## Change Notification CN43-2020

### Packing specification change for AS3412-EWLT

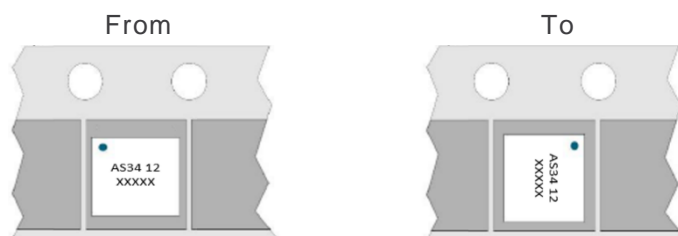
ams has to update pin orientation of AS3412-EWLT, part number 191150045 on carrier, wherein Pin 1 of the device is located from upper left moving to upper right position in reference to internal specification and figure 3 (1 of 2) of EIA-481 standard.

**Reason for change:** Standardize the pin 1 orientation from upper left to upper right position near the round sprocket holes.
